**Comments of the U.S. Department of Energy and Washington TRU Solutions, LLC,
Regarding the NMED's Intent to Approve a Class 3 Permit Modification Request
Pursuant to Public Notice 05-16**

On November 23, 2005, the New Mexico Environment Department (NMED) issued Public Notice No. 05-16 stating that it intends to approve a Class 3 modification to the Hazardous Waste Facility Permit (HWFP) for the Waste Isolation Pilot Plant (WIPP), EPA ID No. NM4890139088. NMED also issued a Fact Sheet setting out the basis for the draft Permit. The Permittees generally support the draft Permit, and with these comments, propose alternative text. Text to be included in the draft Permit not only promotes safe, efficient operations at waste generator/storage sites and at the WIPP, but also increases NMED oversight.

Figure M1-1a
Waste Handling Building Plan (Ground Floor)

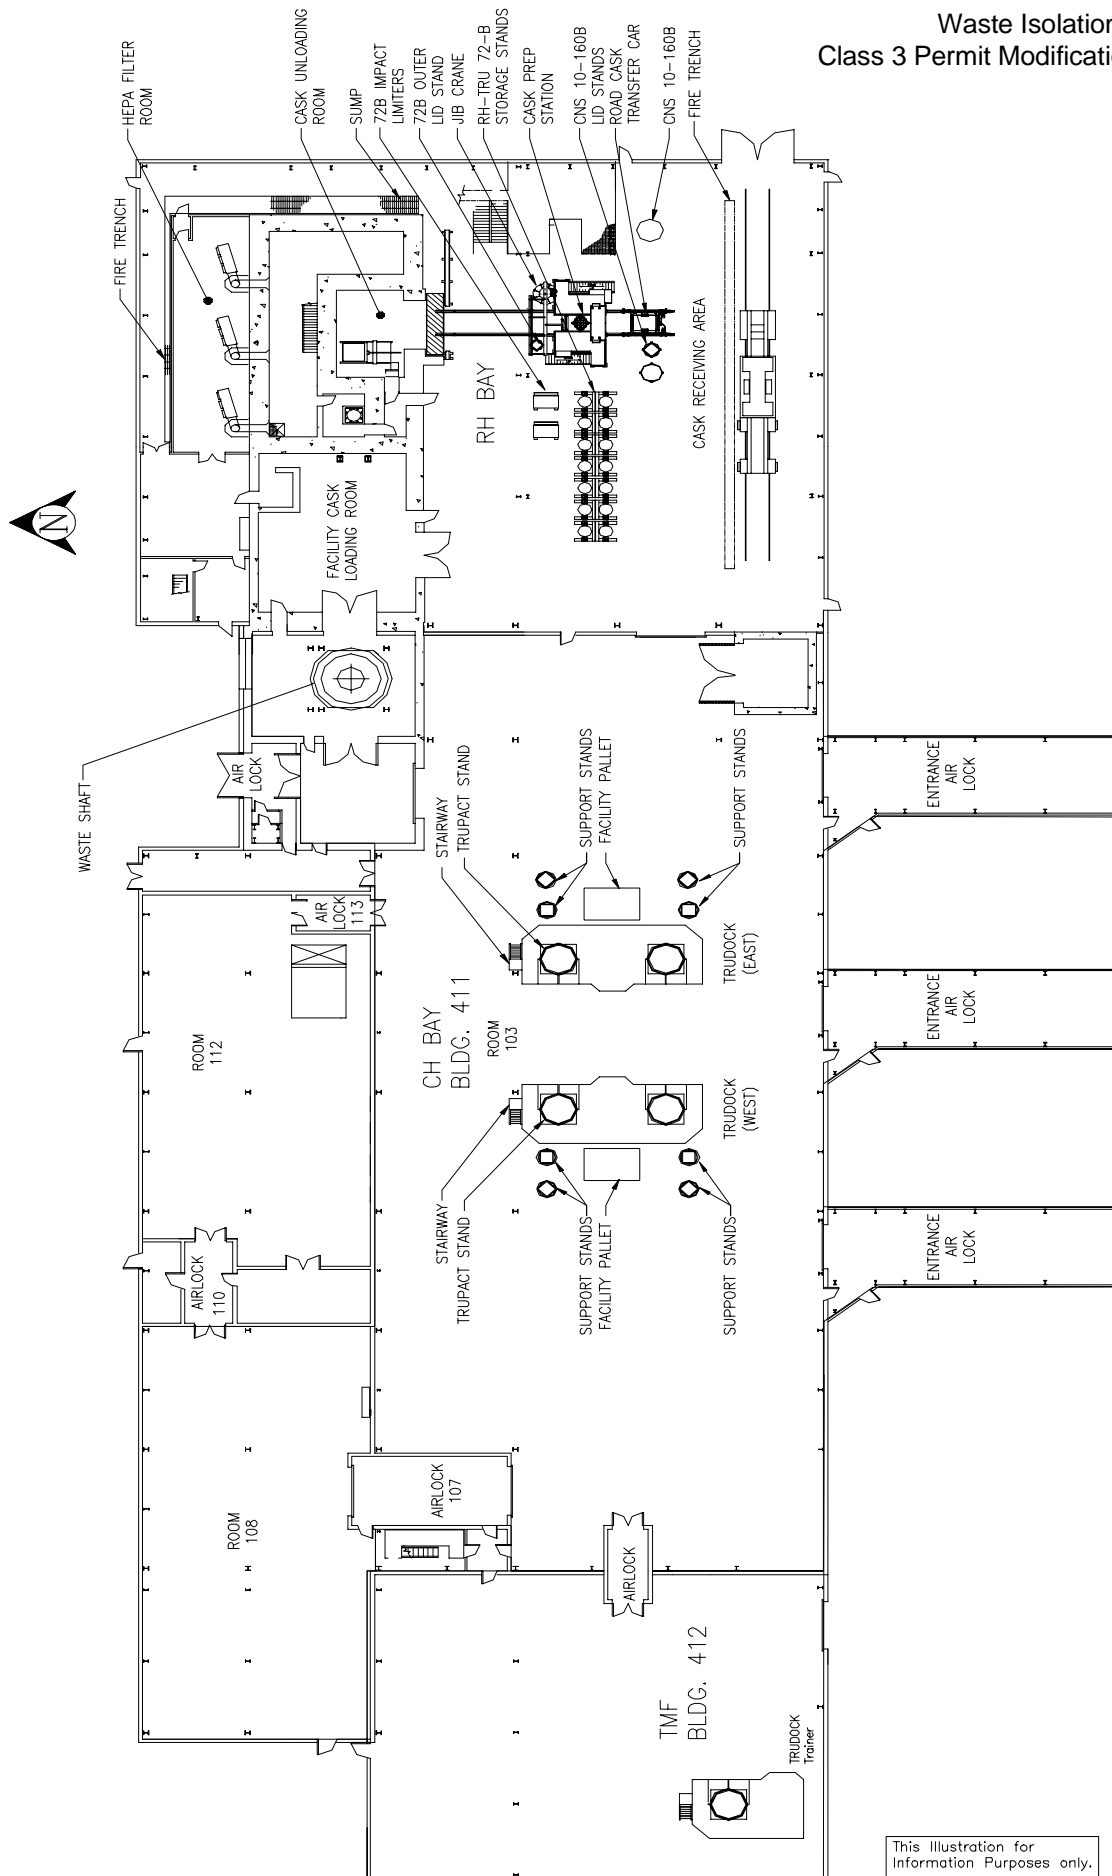
M1-1i	M1-27	3-6	Added the Parking Area Holding Area and indoor container holding areas to the discussion of run on.	In the Parking Area Unit, <u>and Parking Area Holding Area</u> the containers of TRU mixed waste are always in Contact-Handled or Remote-Handled Packages which protect them from precipitation and run on. Therefore, the WIPP container storage units <u>and holding areas</u> will comply with the requirements of 20.4.1.500 NMAC (incorporating 40 CFR §264.175(b)(4)).
Figure M1-1			Reinserted figure with changes.	Revised figure is attached.
Figure M1-1a			Deleted NDE unit in TMF.	Revised figure is attached.

Figure M1-2
Parking Area - Container Storage Areas

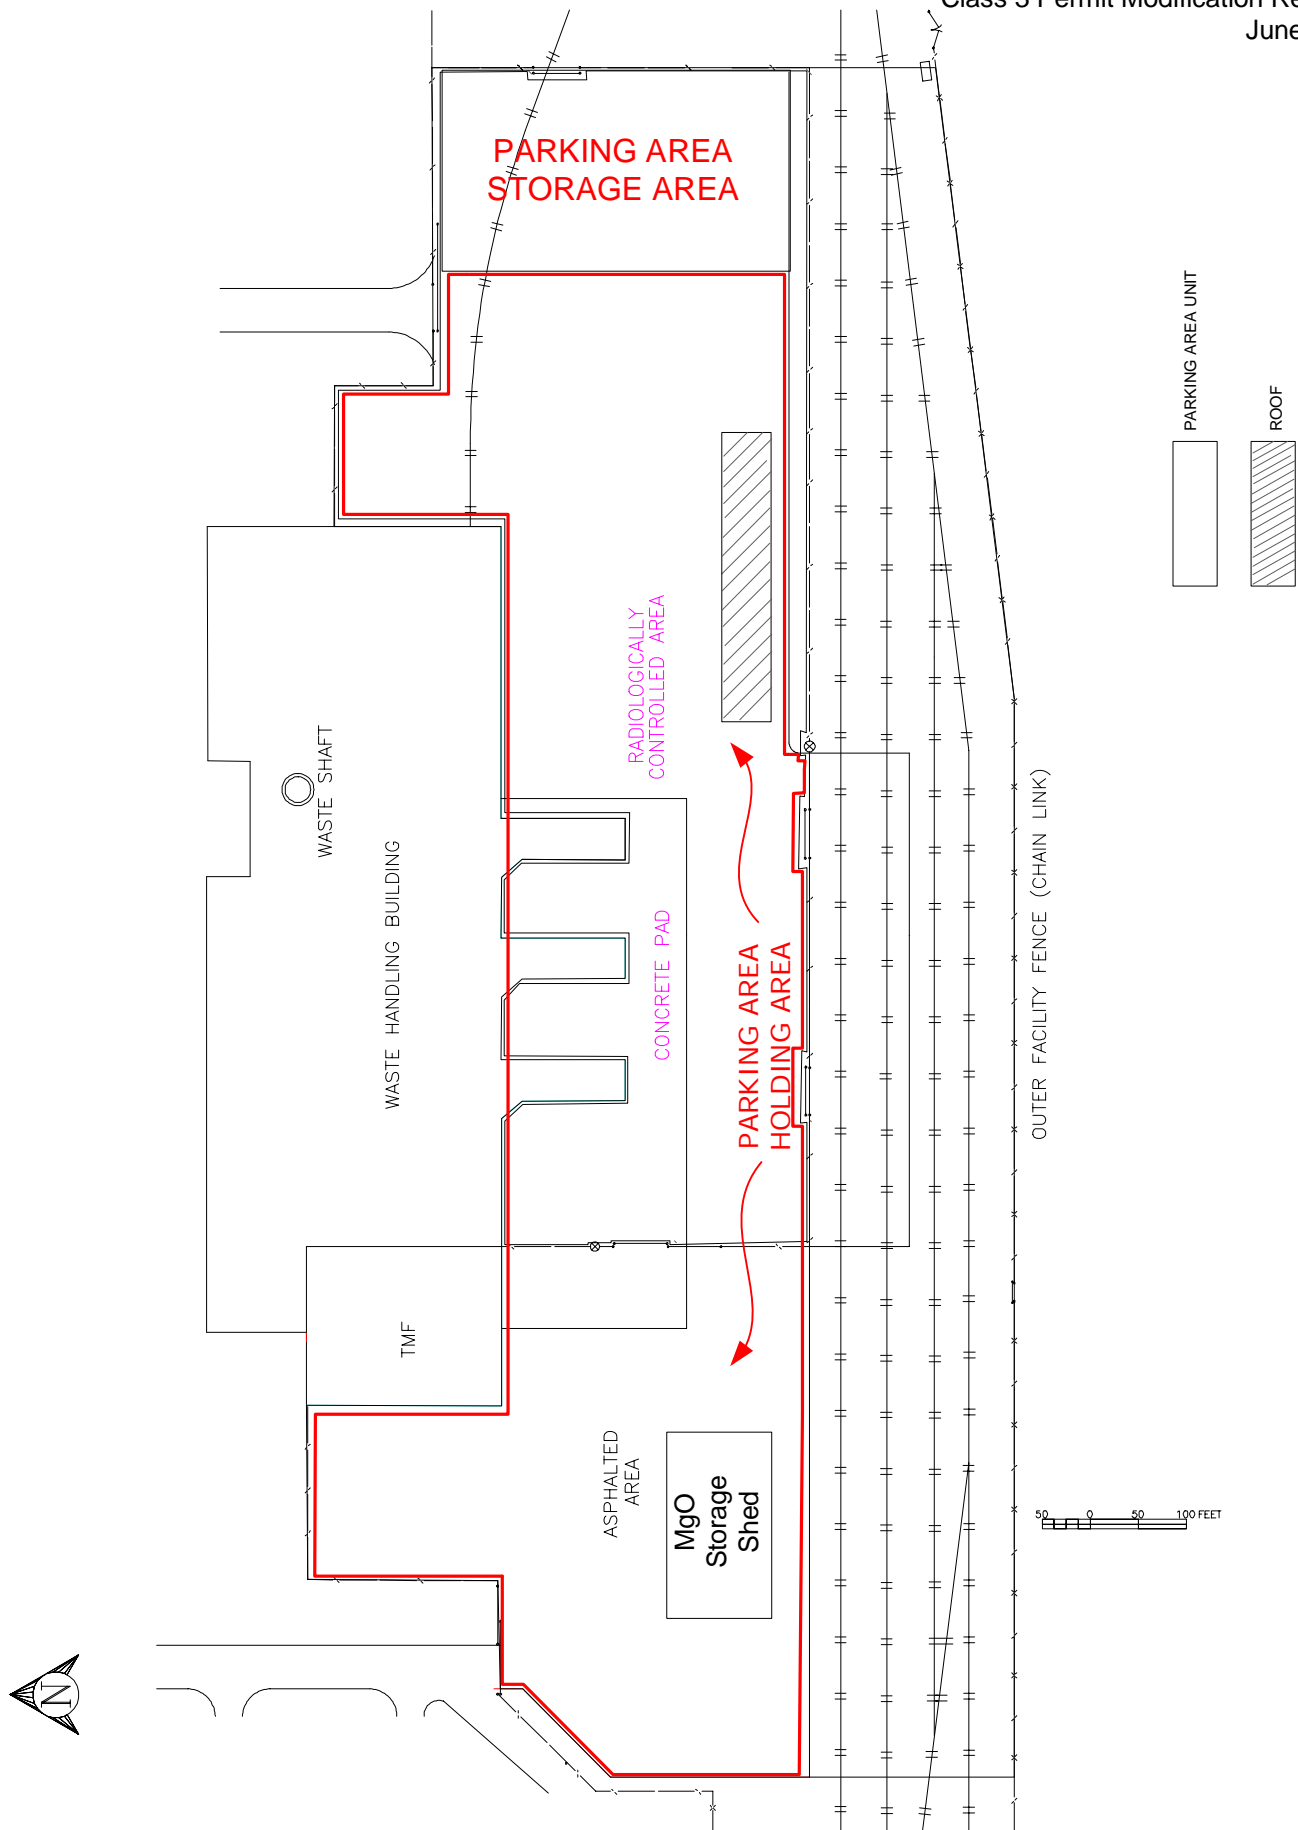
Att/Module and Section	Page	Line	Comment	Proposed Change to Draft Permit
Figure M1-2			Reinserted figure with changes.	Revised figure is attached.
Figure M1-7			Deleted facility pallet temporary storage area figure. The information on this figure is the shown in Figure M1-1.	Deleted figure is attached.
Figure M1-9			Deleted WHB unloading dock figure. The information on this figure is the shown in Figure M1-1 and M1-1a.	Deleted figure is attached.
Figure M1-13			Reinserted Permittees Figure M1-13 and change "verification and examination" to "confirmation."	Revised figure is attached.
Figure M1-14			Deleted ground floor area figure. The information on this figure is the shown in Figure M1-1 and M1-1a.	Deleted figure is attached.
Figure M1-18			The term "Lift Trunnions (4 places)" was not captured in the NMED version of this figure.	Corrected figure is attached.
Figure M1-28			Replaced figure. What is depicted is the process flow for the RH-72B and not the CNS 10-160B. Figures M1-28 and M1-29 in the draft Permit are duplicates.	Revised figure is attached.
